Millstone Nuclear Power Station, Unit No. 2
Feedwater System Piping

RESPONSES TO
ADDITIONAL INFORMATION REQUIRED
TO ASCERTAIN ACTIONS NECESSARY
REGARDING THE FEEDWATER SYSTEM PIPING

ASSESSMENT OF GROWTH OF FEEDWATER LINE FLAWS

FIGURE 1.

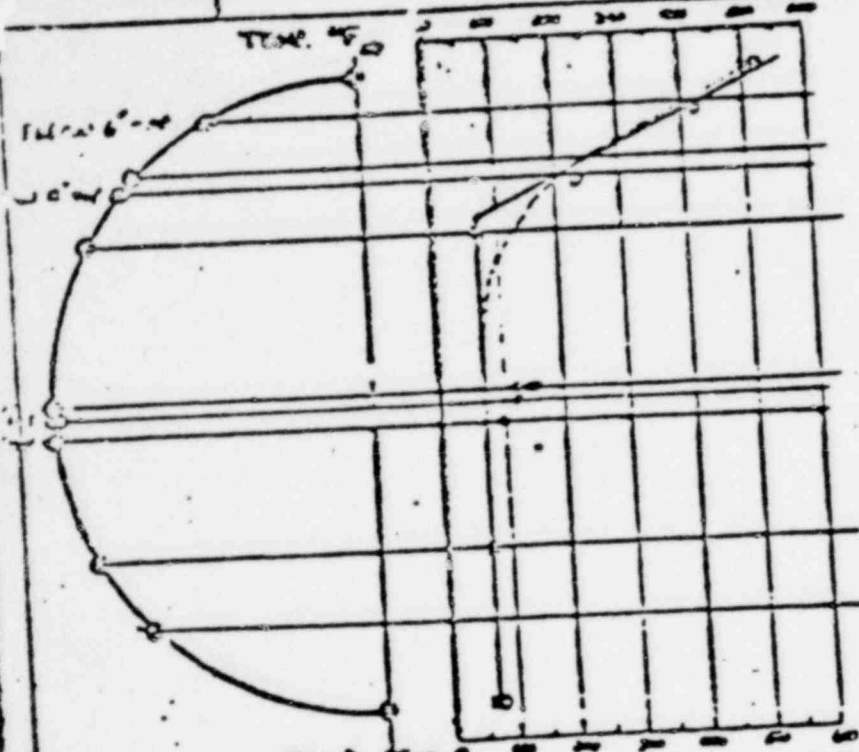
A three dimensional finite element stress analysis has been completed for each of the five temperature profiles in Figure 1, and transient studies have shown that the five profiles represent limiting conditions compared with the stress results obtained for any transient step in between the profiles.

FIGURE 2 : SUMMARY OF TEMPERATURE PROFILE OCCURRENCES

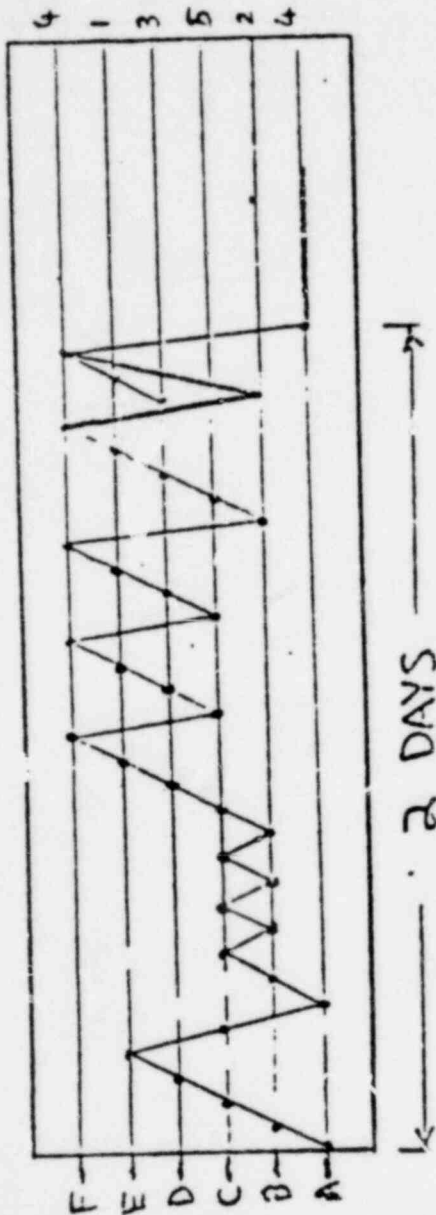
To accomplish a fatigue crack growth analysis, the system design transients for normal, upset and test conditions were combined with the cycles of stress from stratification, which occurs during hot standby operation. As shown in Figure 2, there are approximately nine cycles of various degrees which for the purpose of this analysis, we will assume, occur each time hot standby occurs.

FIGURE 3 FATIGUE CRACK GROWTH DATA FOR SA-509, CLASS 2 AND CLASS 3 AND SA-553, GRADE B, CLASS 1 STEELS

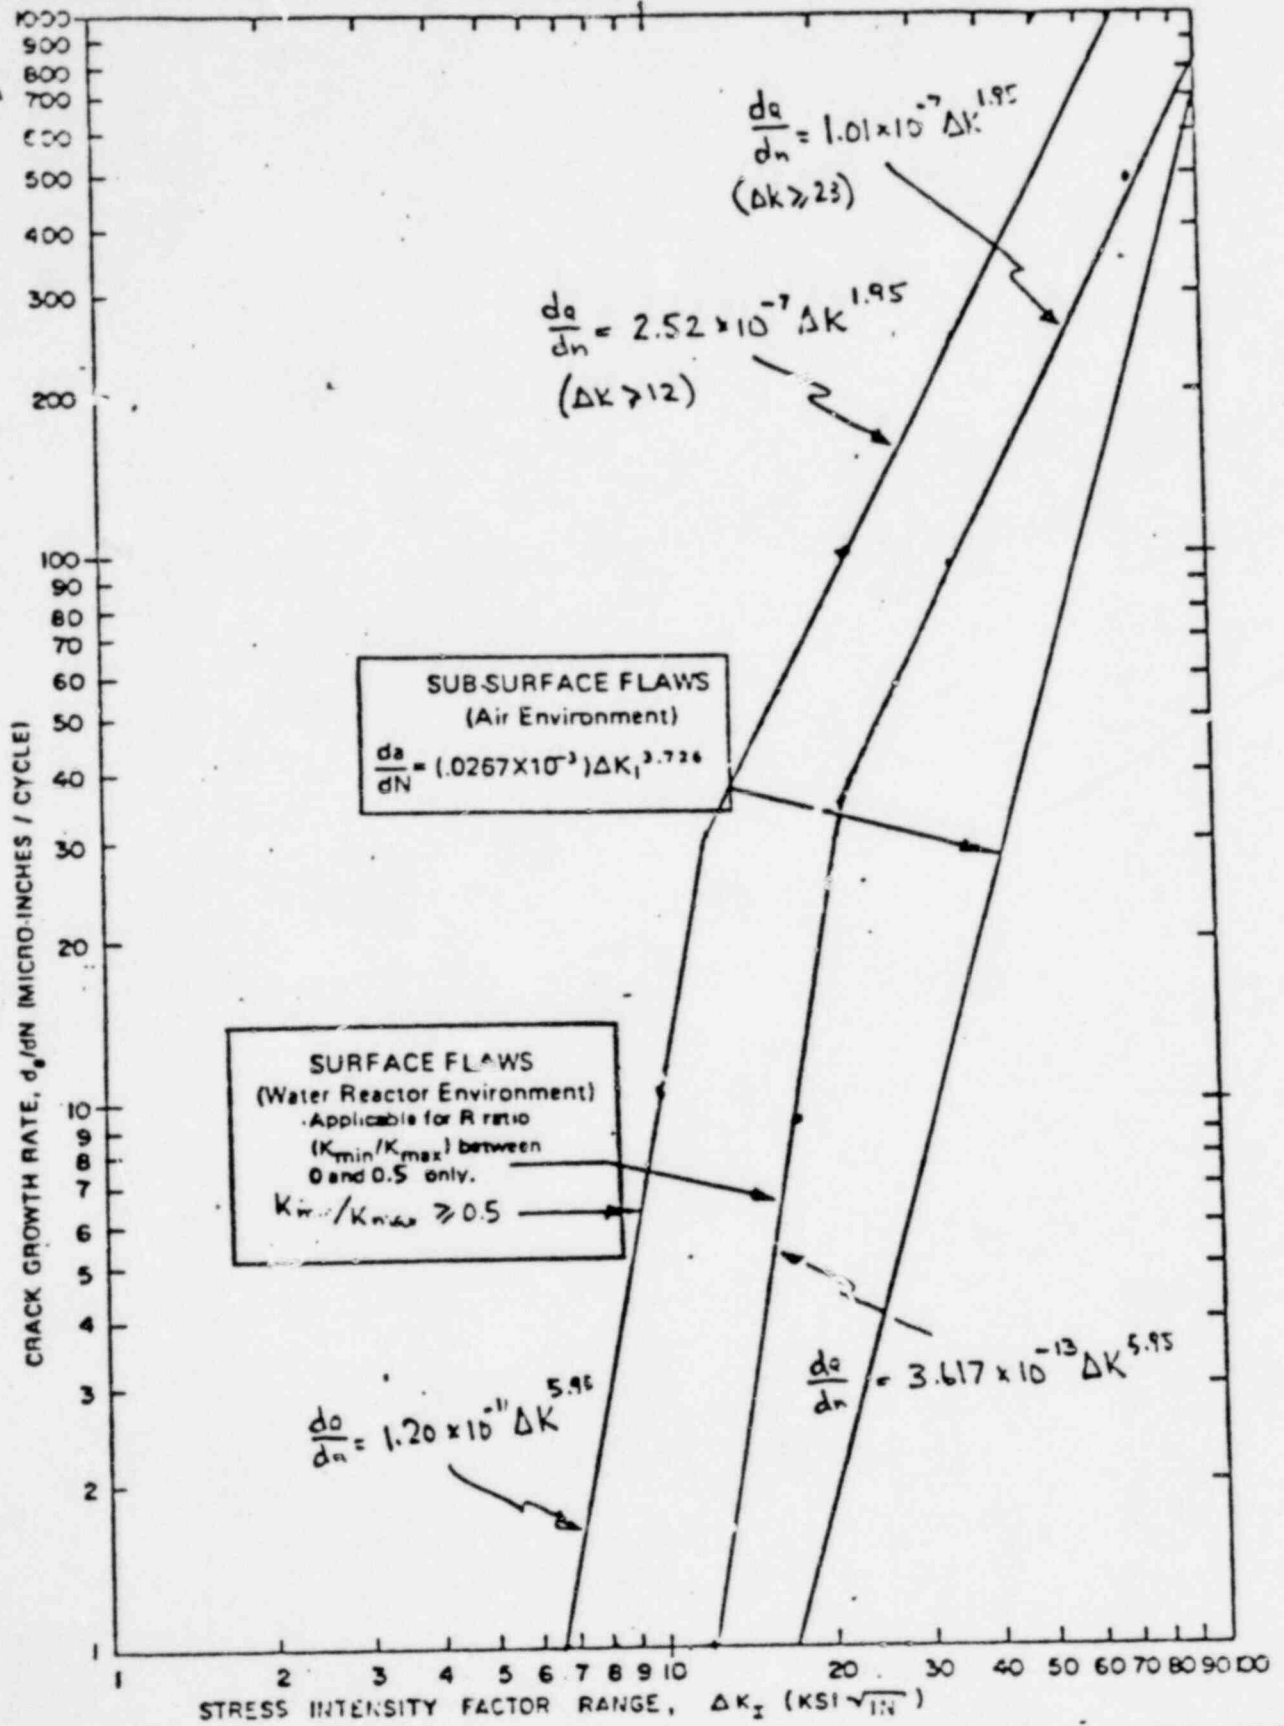
A fatigue crack growth law which accounts for mean stress or R ratio ($\sigma_{min.} / \sigma_{max.}$) as well as the presence of the water environment was used. The law is shown in Figure 3.

FIG. 6. FAILURE PREDICTIONS - 18" OD PIPE 0.75" WALL

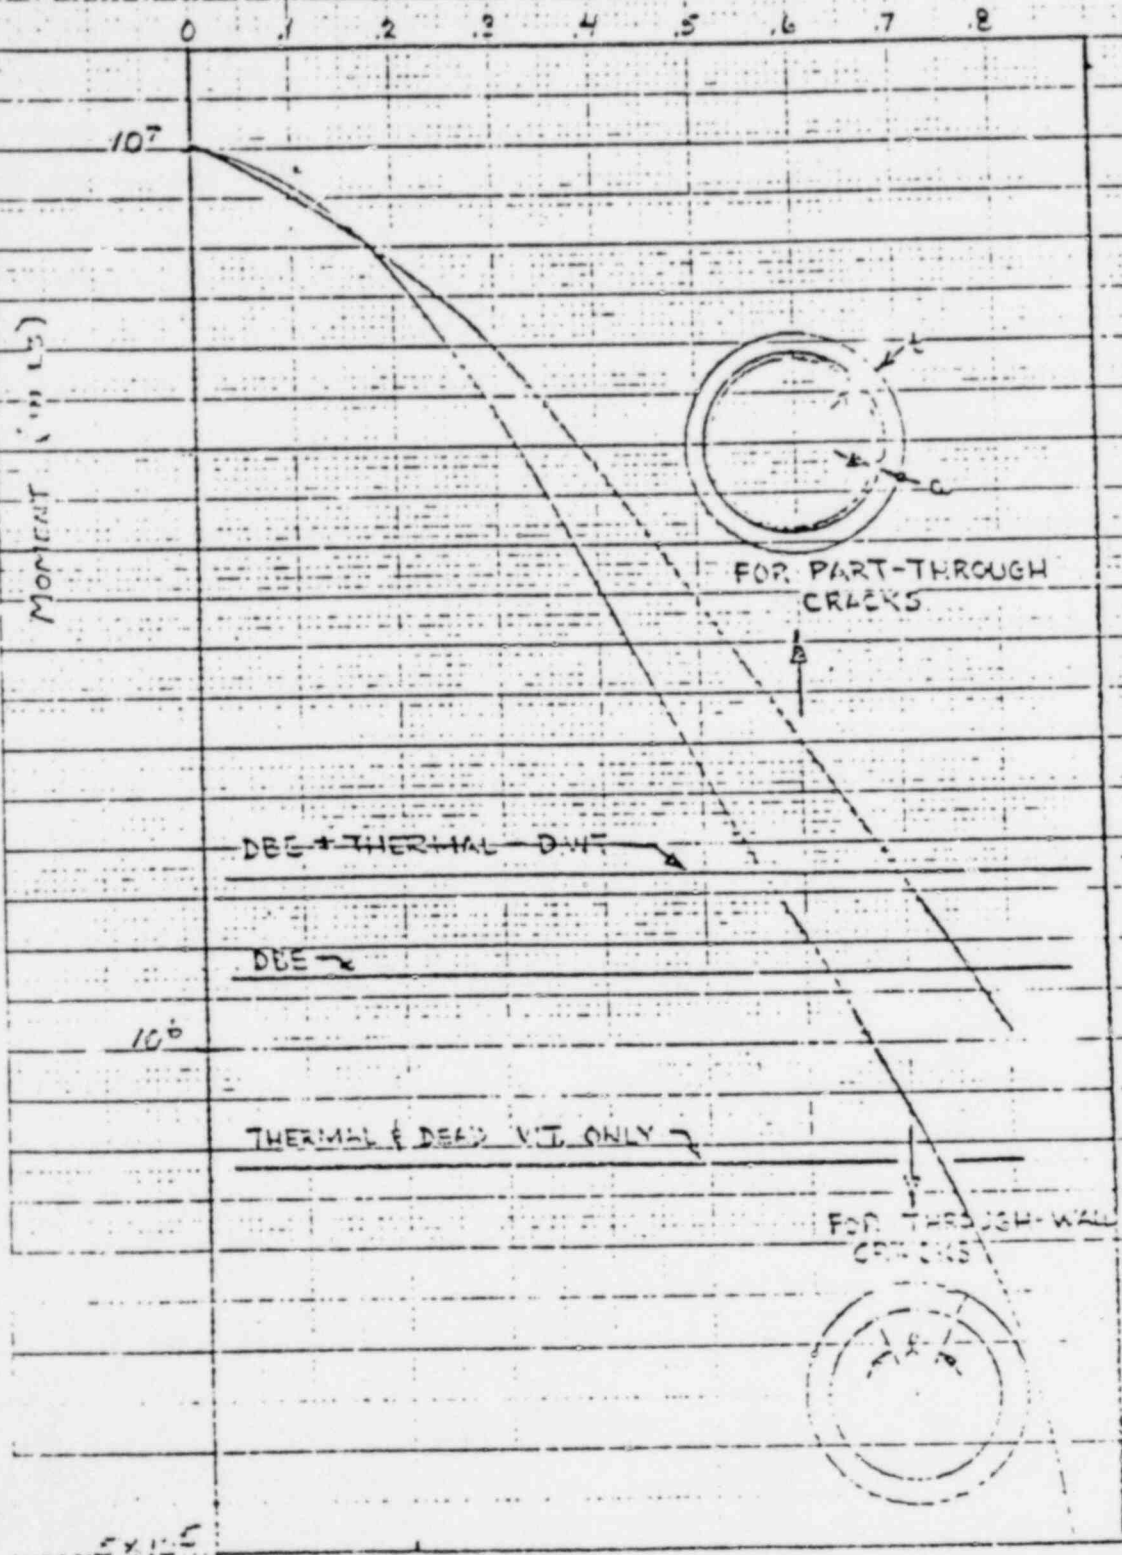
Results of the crack growth analysis are shown in Table 6, for each of the locations considered. These results show that the observe flaws will not grow significantly during the next years service. The final flaw size for the worst location is a factor of 5 smaller than the critical flaw size for the pipe, as shown in Figure 4.
